Service Bulletin No: 25-059

Modification No: EC-25-0067

**EQUIPMENT AND FURNISHINGS - PASSENGER COMPARTMENT
IMPROVEMENT TO THE PSU TRIM PANEL INSTALLATION ABOVE THE EMERGENCY EXIT****1. Planning Information****A. Effectivity**

Installation of dual-lock fastener tape
Figure 1 (Sheet 1 of 2)

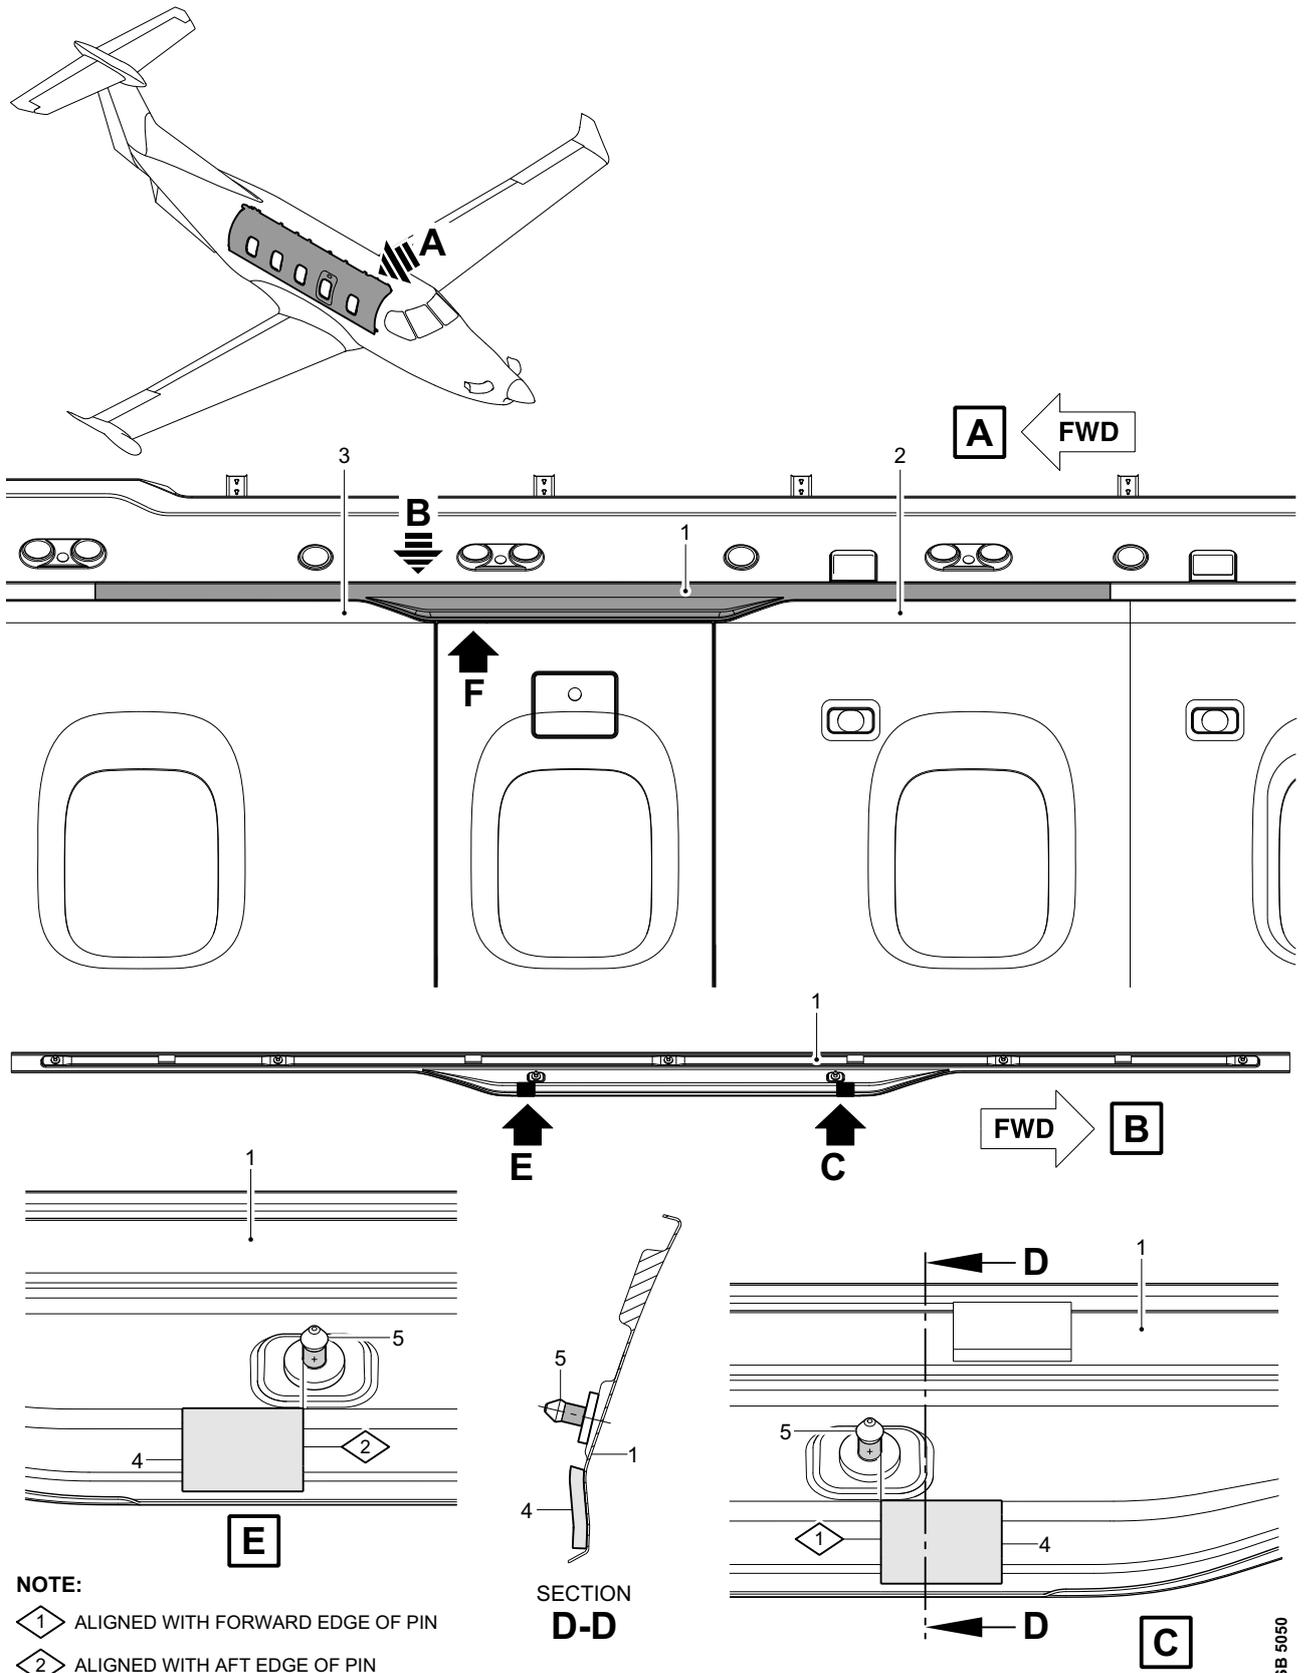
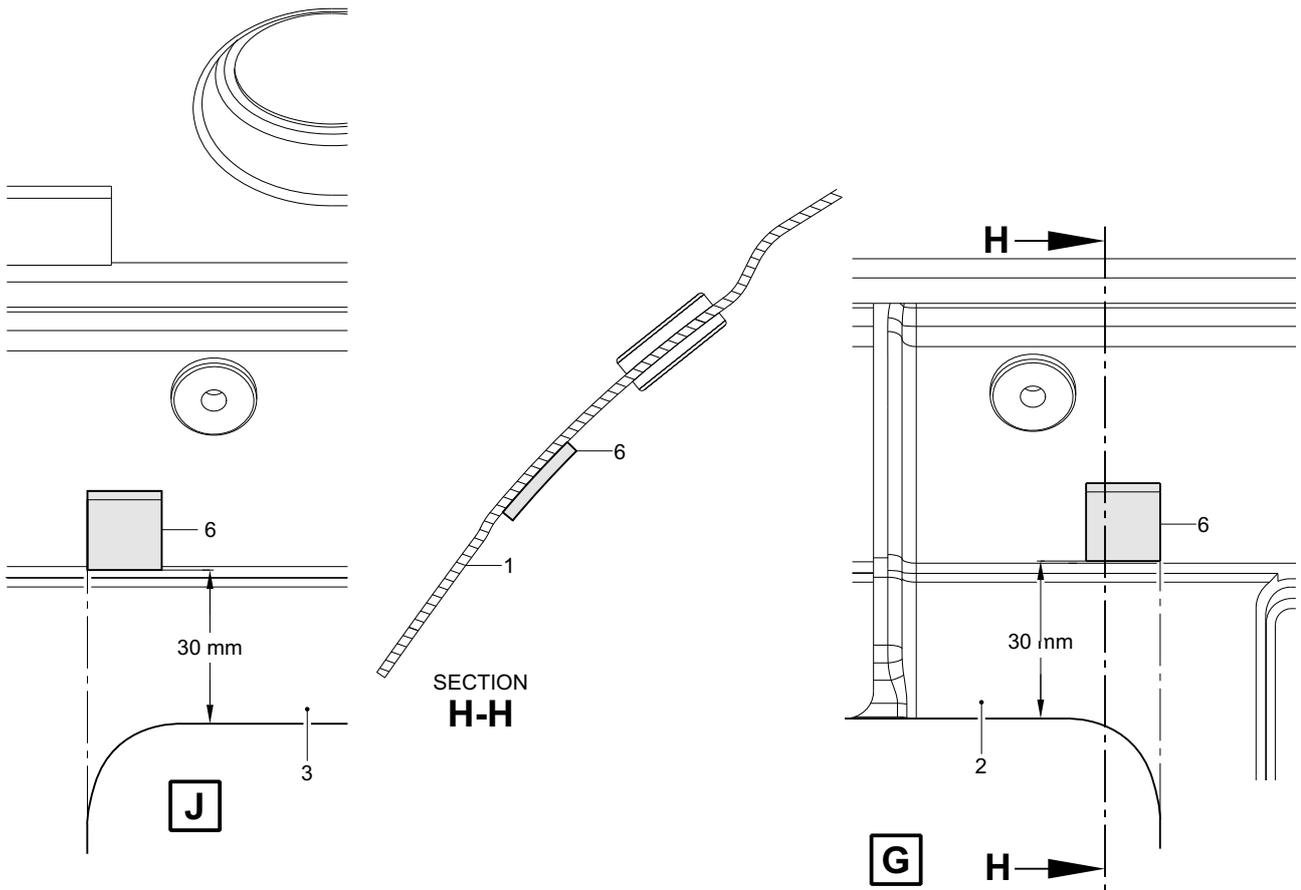
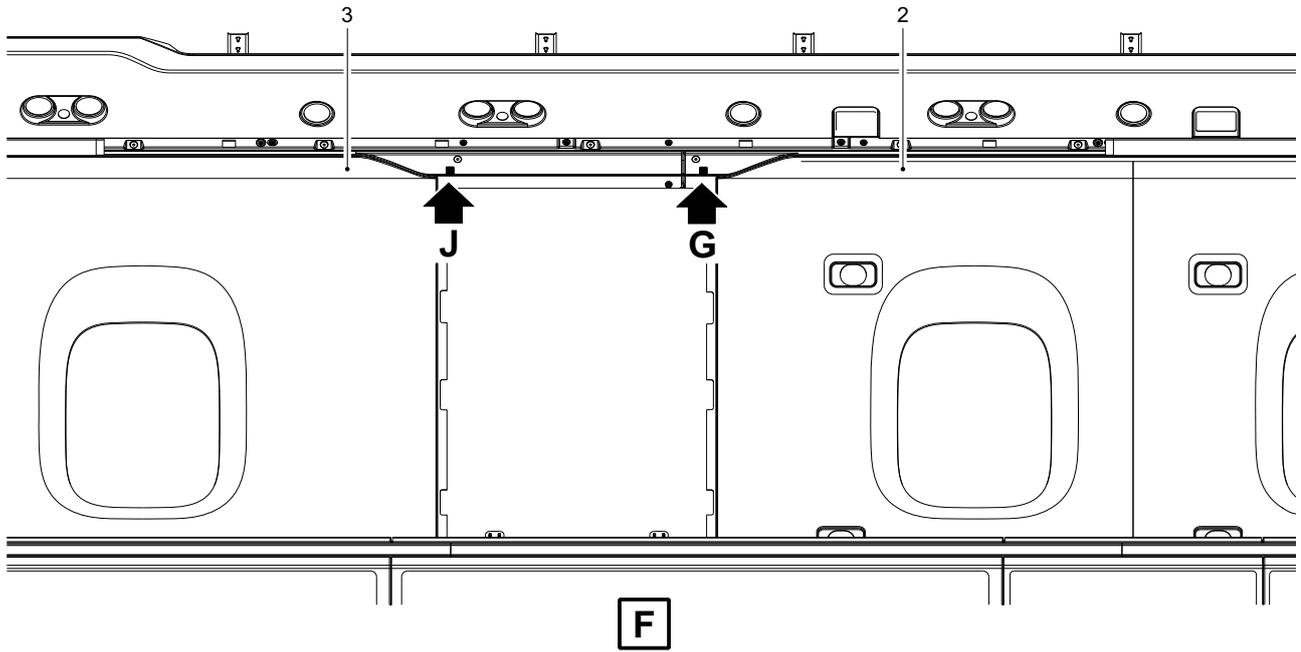
During an inspection it was identified that it is possible for the PSU trim panel (installed above the emergency exit door) to block the opening of the emergency exit. This is possible if the PSU trim panel is positioned too far inboard due to incorrect installation, which can cause interference with the emergency exit door panel.

- (1) Remove and keep the PSU, trim panel RH (1) from over the emergency exit door in the passenger compartment. Refer to AMM 12-C-25-21-03-00A-920A-A.
- (2) Do a visual inspection for the installation of the dual-lock fastener tapes (4) and (6) on the panels that follow:
Refer to views C, E, G, and J.
 - FWD, Upper, RH (3)
 - AFT, Upper, RH (2)
 - PSU, trim panel RH (1).
- (a) If the dual-lock fastener tapes (4) and (6) are installed, install the PSU, trim panel RH (1) that you kept.
Refer to AMM 12-C-25-21-03-00A-920A-A.
 - 1 Make sure that the PSU, trim panel RH (1) is installed correctly and the dual-lock fastener tape (4) and (6) are engaged.
 - 2 Continue with the 'Requirements after job completion' and 'Documentation' sections of this Service Bulletin.
- (b) If the dual-lock fastener tapes (4) and (6) are not installed go to Part 2 of this Service Bulletin, refer to Para 3.C.

- (1) Cut two pieces of the dual-lock fastener tape (4) (P/N 917.47.28.046) to 20 x 25 mm (0.79 x 0.98 in).
- (2) Cut two pieces of the dual-lock fastener tape (6) (P/N 917.47.28.045) to 13 x 13 mm (0.51 x 0.51 in).
- (3) If necessary, remove the panel cover material (leather/vinyl) in the installation area of the dual-lock fastener tape (6). Refer to views G and J.

- FWD, Upper, RH (3)
 - AFT, Upper, RH (2)
 - PSU, trim panel RH (1).
 - (a) Make sure that the dual-lock fastener tape (4) on the PSU, trim panel RH (1) is aligned with the locator pins (5). Refer to views E and C.

- (b) Make sure that the dual-lock fastener tape (6) is aligned with the edge of the panels (2) and (3) and 30mm (1.18 in) above the emergency exit. Refer to views G and J.

- (4) Use wipes, presaturated solvent (Material No. P01-033) to clean the installation positions of the dual-lock fastener tapes (4) and (6) on the panels that follow:
Refer to views C, E, G, and J.

- FWD, Upper, RH (3)
 - AFT, Upper, RH (2)
 - PSU, trim panel RH (1).
- (5) Let the solvent dry.
- (6) Apply a thin layer of adhesive (Material No. P08-080) to the mating surfaces of the dual-lock fastener tapes (4) and (6) and the panels that follow:
Refer to views C, E, G, and J.

- FWD, Upper, RH (3)
 - AFT, Upper, RH (2)
 - PSU, trim panel RH (1).
- (7) Let the adhesive cure as per the manufacturers instructions.
- (8) Install the dual-lock fastener tape (4) and (6) on the mating surfaces of the panels that follow:
Refer to views C, E, G, and J.

- (1) Install the emergency exit door. Refer to AMM 12-B-52-20-00-00A-920A-A.
- (2) Make sure that the PSU, trim panel RH (1) has sufficient clearance with the emergency exit door. Refer to Figure 1.
- (3) Remove all tools and materials. Make sure that the work areas are clean.
